COMPLETE REVISION HISTORY TO THE 2015 I-CODES®

**Complete Revision History to the 2015 I-Codes: Successful Changes with
Public Comments: 2015 IRC**

First Printing: September 2014

PROPER PLACEMENT OF BOLTS WITH CODE CHANGE

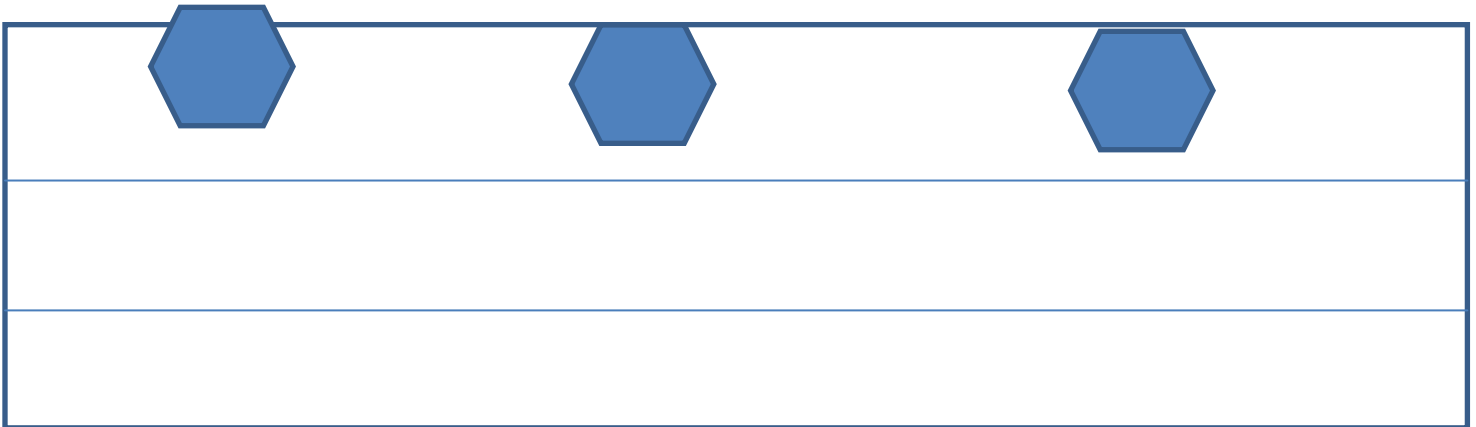
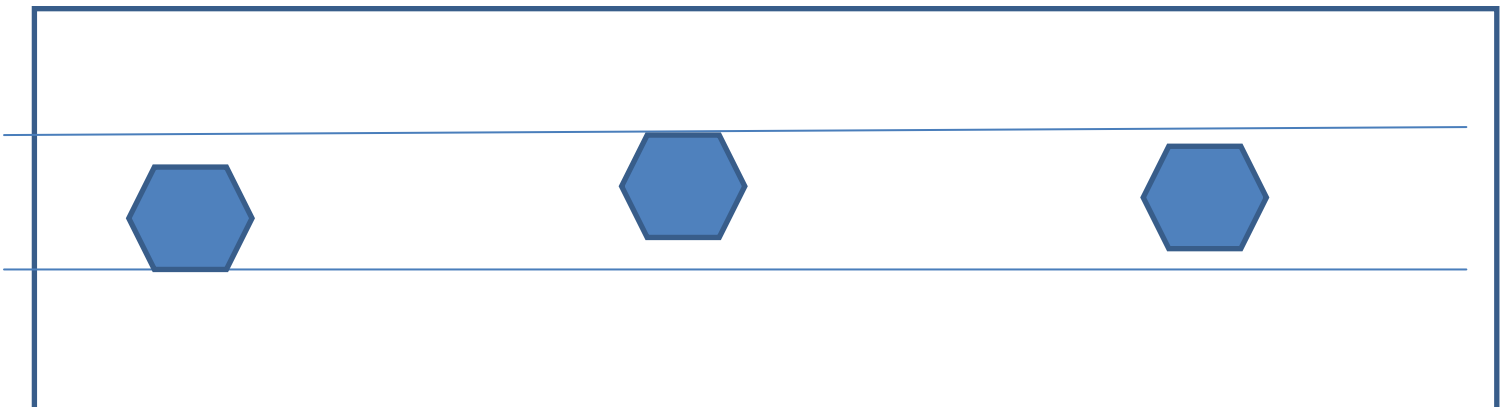
Both the Simpson Strong Tie Wood Construction Connectors 2011-2012 edition and the USP Structural Connectors state that their connectors must have a minimum placement of 1 3/4 inches from the edge.

The IRC reference the NDS for wood design for items not covered in the code like wood edge and end distances. The 2012 NDS has edge distance of 3/4" for shear and 2" for wind loads (Table 11.5.1C). So if the edge distance is 1-1/8" you would need to reduce the anchor capacity with an 0.56 allowable load adjustment factor (1.125/2) when resisting wind loads. So you can space in the middle 1/3 of plate, but you may need to increase the number of bolts for wind.

FIGURE R602.7.2
TYPICAL WOOD STRUCTURAL PANEL BOX HEADER CONSTRUCTION

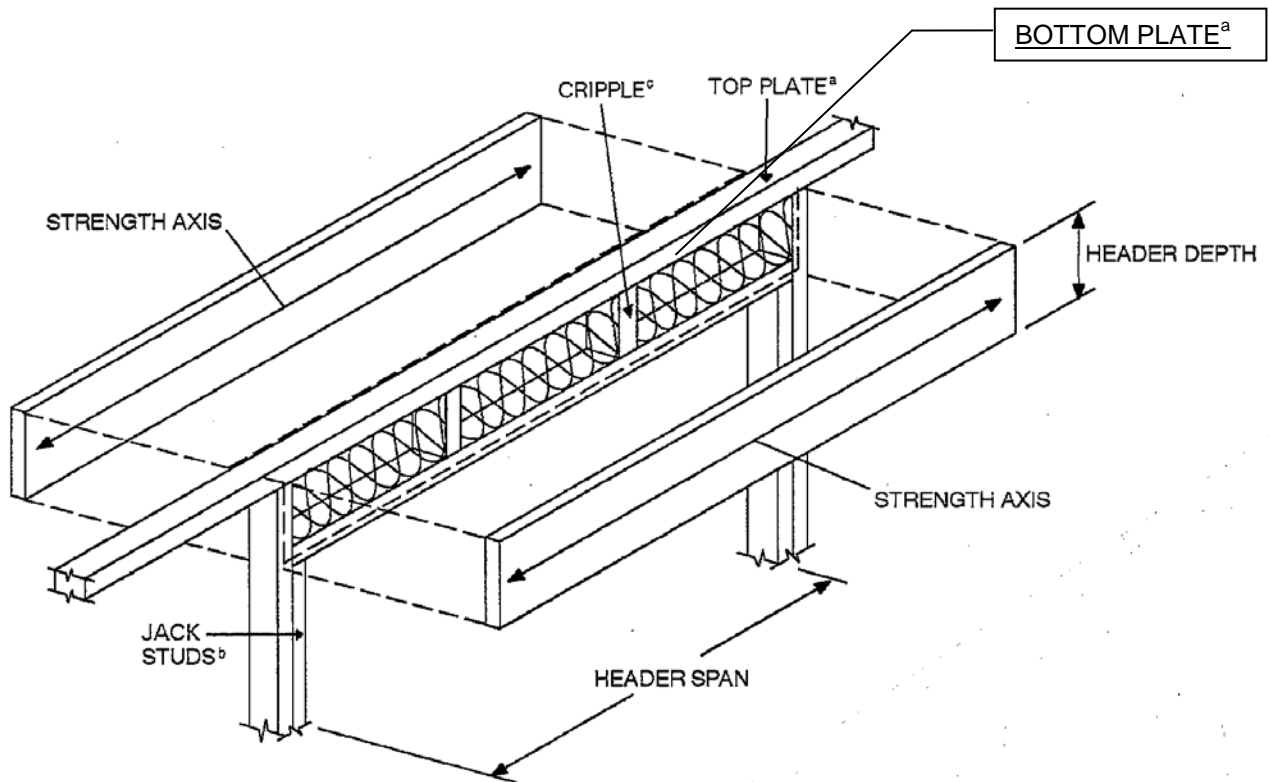
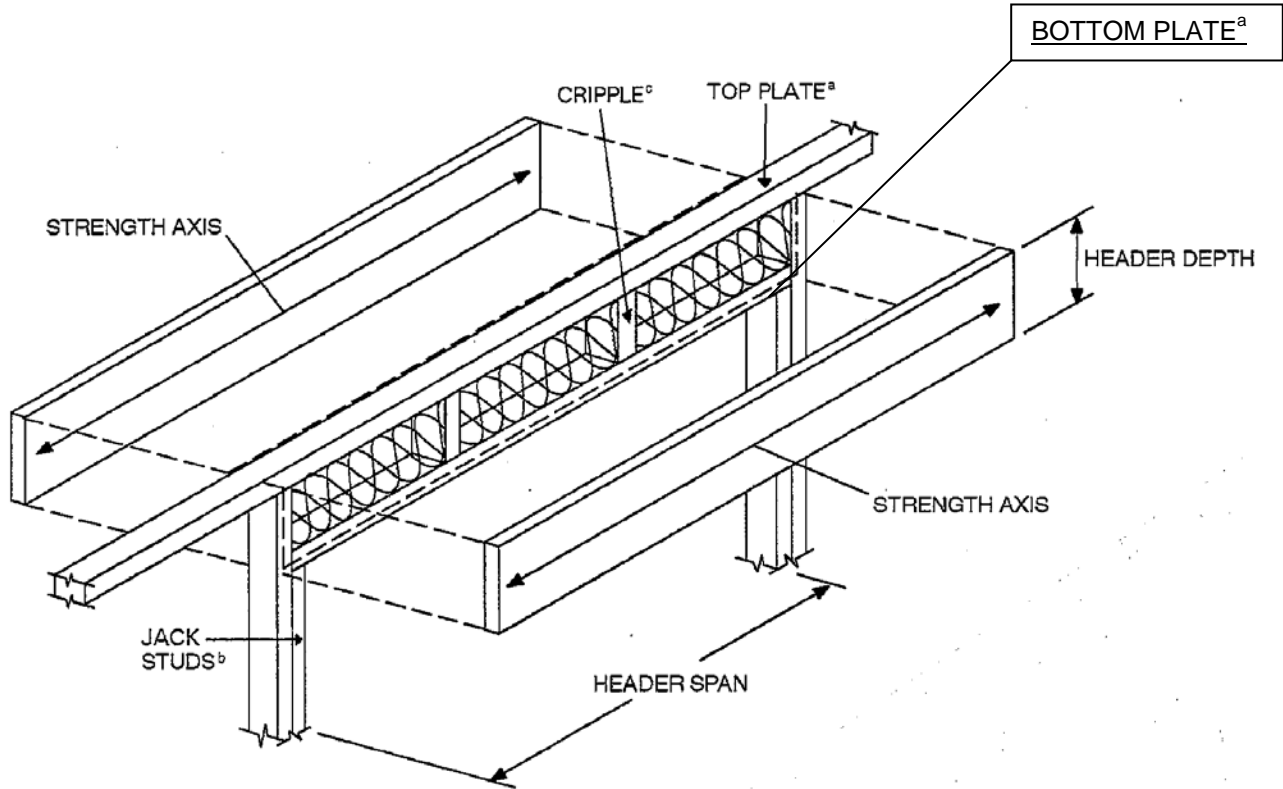
The following is errata that was not posted to the ICC website (The line from "Bottom Plate" has been shifted):

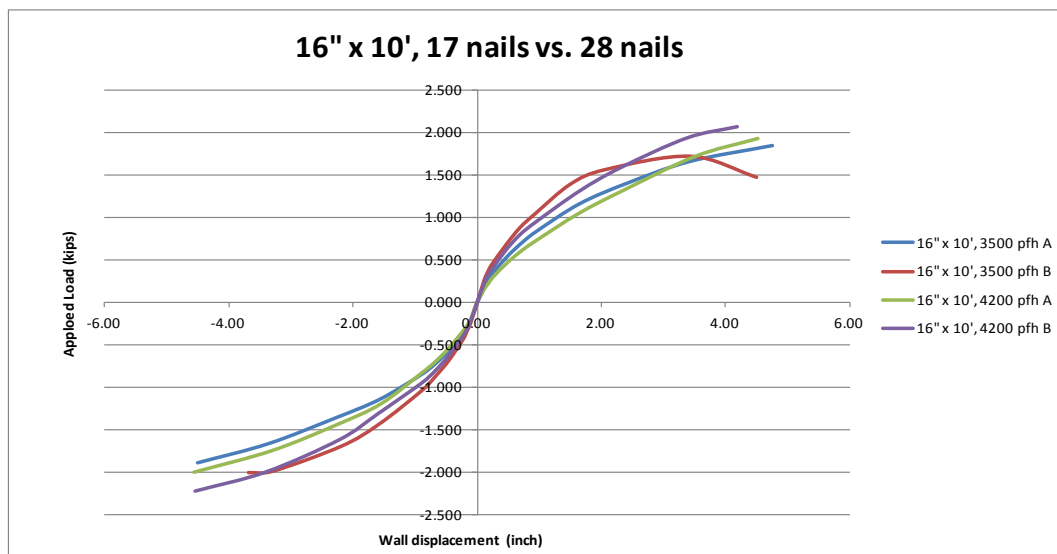
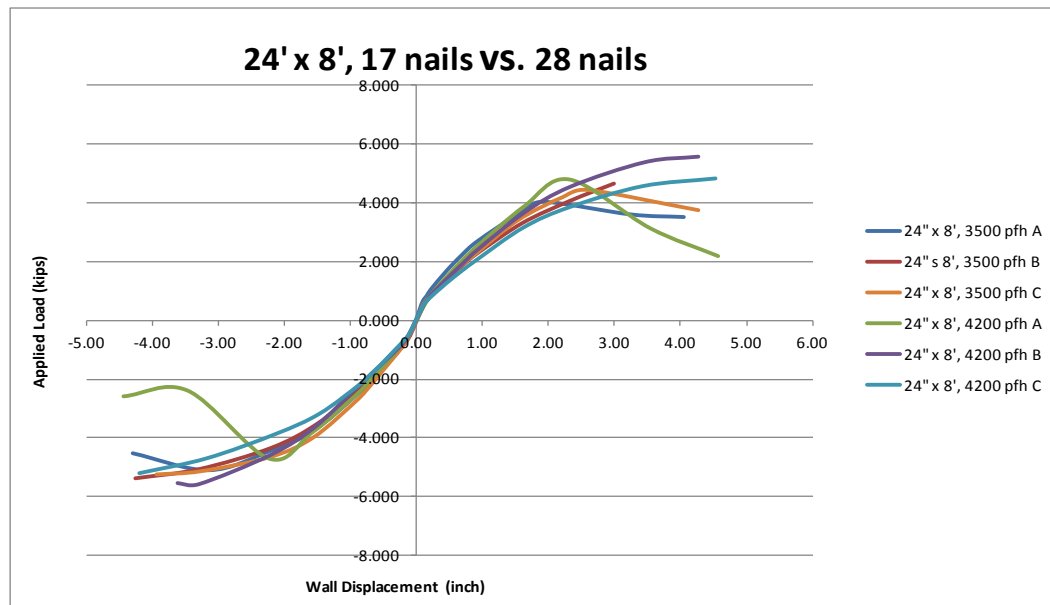
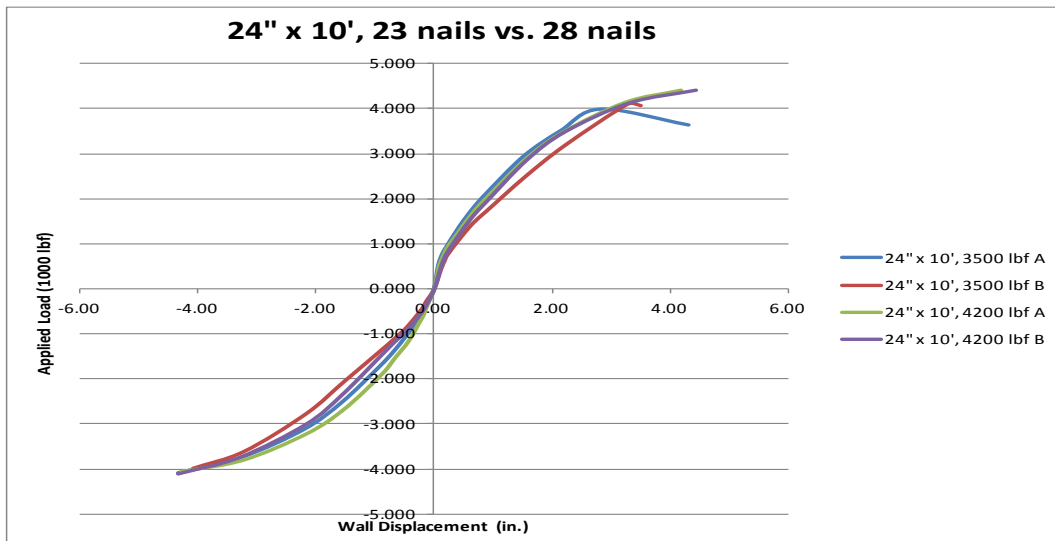
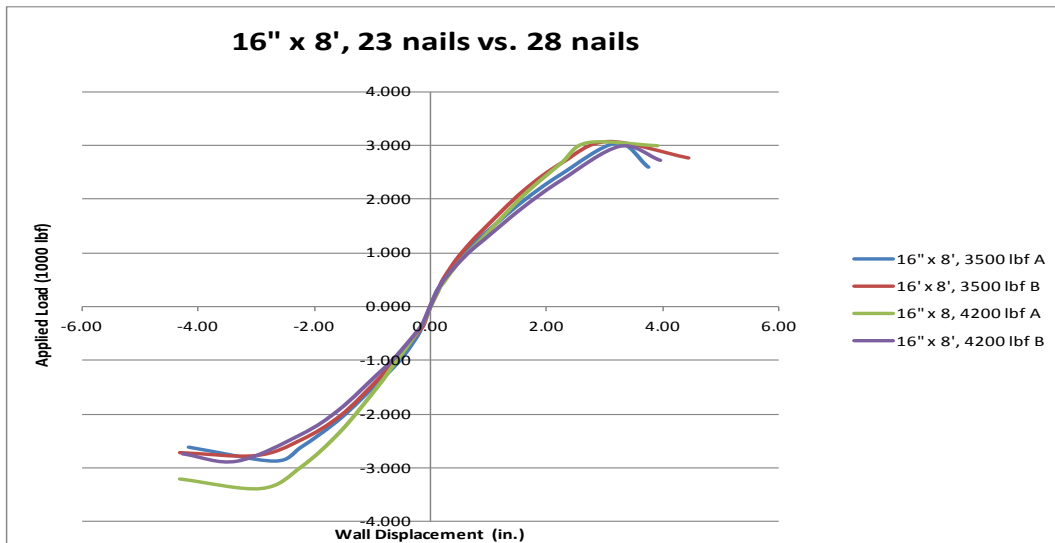
1) There are a couple of types of changes to Figure 2308.9.3.2 proposed. There are both technical changes and editorial changes.

The results of the above tests agree favorably with previous testing conducted with varying numbers of fasteners as seen below:

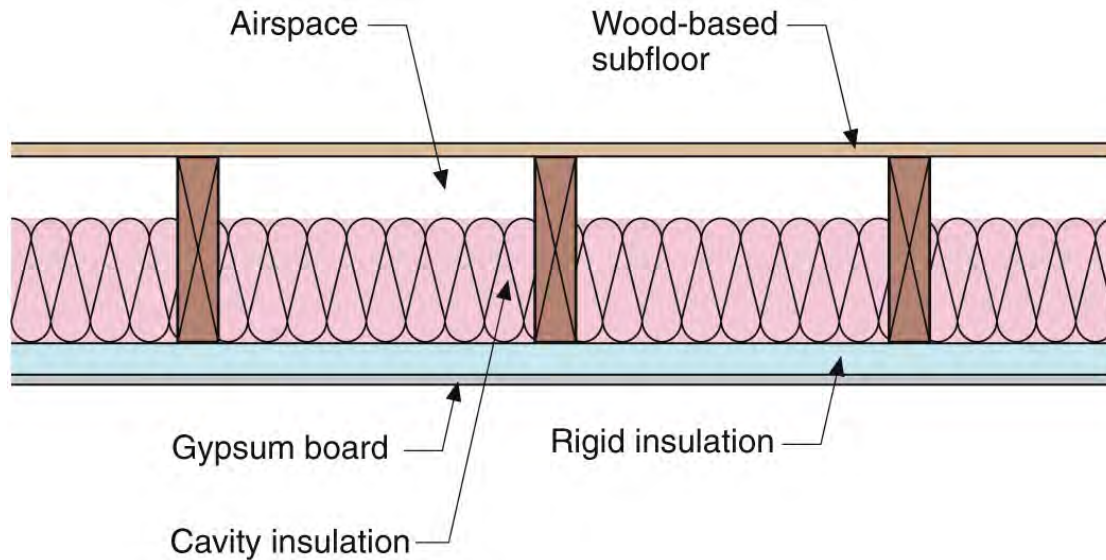
Reason: Requiring insulation in floors to be in direct contact with the underside of subfloor decking is one insulating option. Another option is to have an airspace between the floor sheathing and the top of the cavity insulation where this cavity insulation is in direct contact with the topside of sheathing or continuous insulation installed on the underside of the floor framing and is combined with perimeter insulation that meets or exceeds the R-value requirements for walls. This second option leads to fewer cold spots yet does not change the heat loss as long as the cavity insulation is in direct contact with a sheathing below it or continuous insulation below it. It also facilitates services to be enclosed within the thermal envelope. Examples of these configurations are illustrated below:
